SUNDRY NOTICES AND REPORTS ON WELLS

McConnell 8

PLUG AND ABANDONMENT PROCEDURE

CONDITIONS OF APPROVAL

Proposed P&A

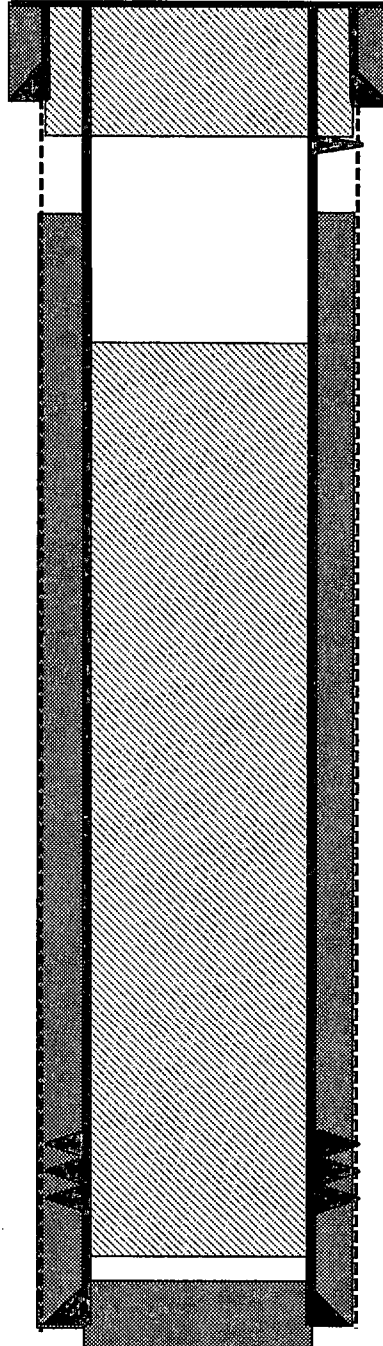
1. Plugging operations authorized are subject to the attached "General Requirements for Permanent Abandonment of Wells on Federal and Indian Leases."
2. Farmington Office is to be notified at least 24 hours before the plugging operations commence (505) 564-7750.
3. The following modifications to your plugging program are to be made:
 - a) Bring the top of plug #1 to 1036 ft. to cover the Ojo Alamo top. Adjust cement volume accordingly.

Operator must run a CBL from 2101 ft., or as deep as possible, to verify cement top. Outside plugs may be revised, based on CBL result. Submit electronic copy of the log for verification to the following BLM address: tsalyers@blm.gov
